Service Information Letter

SIL# SL 1-33082-0804
Rev D

SUBJECT: MARATHONNORCO AEROSPACE BATTERY

MODEL: M³-25-1

Figure 1

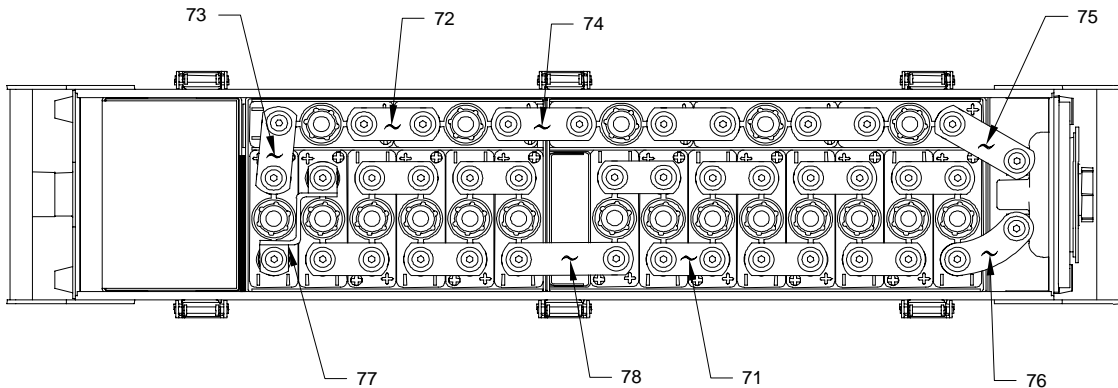
- 1.4 Run down battery using a resistance load bank to a voltage of 8.0 Volts and clip off individual cells.
- 2.0 Disassemble Battery – Refer to Figure 1 & 2, and Figure 5 for parts list.

- 2.1 Remove all intercell connector screws and Bellville washers and then remove intercell connectors. Intercell connectors that can be discarded: Item number 72 (2), 74, 75, 77, & 78 on the follow Illustration.

Figure 2

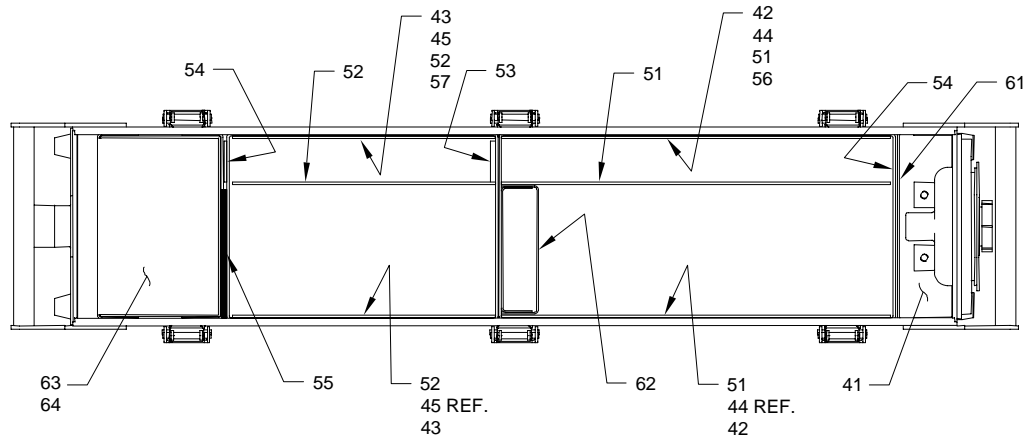
- 2.2 Remove and discard all cells.
 - 2.2 Remove middle and front spacer assemblies and discard. Item 61 and 62 pictured below.

- 2.3 Remove all shims and liners, number each as to it's corresponding number above.
- 2.4 Remove rear spacer (Item #63) and bag liners and thoroughly clean and inspect all components.
- 3.0 Assemble Battery - Refer to Figures 3 & 4; and Figure 6 for parts list.
- 3.1 Install rear spacer and new front spacer assembly (Item # 61, P/N: 33101-002) and install bag liners, liners and shims into the new configuration below.

Figure 4

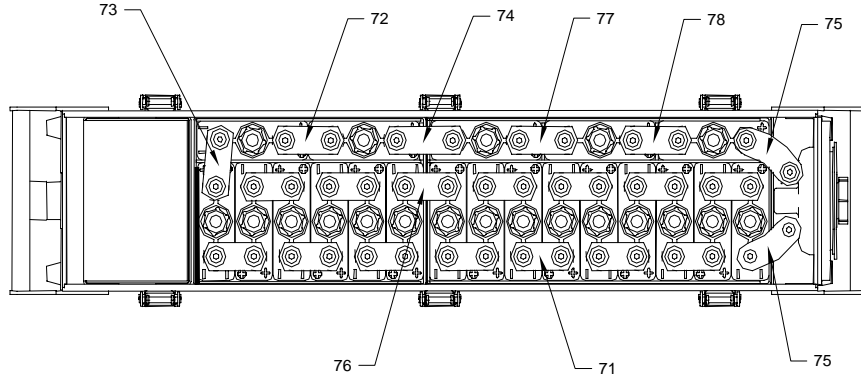
- 3.2 Install 20 new cells into the new configuration below, making sure to orient the positive and negative terminals exactly as in the illustration.

- 3.3 Install the intercell connectors, Bellville washers, and socket screws. Be sure to torque screws to 45 – 50 Inch-pounds. Substitute the new intercell connectors as follows:

New P/N	Replaces	Old P/N	Detail Drawing Item #
16102-015		16102-078	74
18006-001		16102-010	75
16102-006		16102-053	77
16102-018		16105-053	78
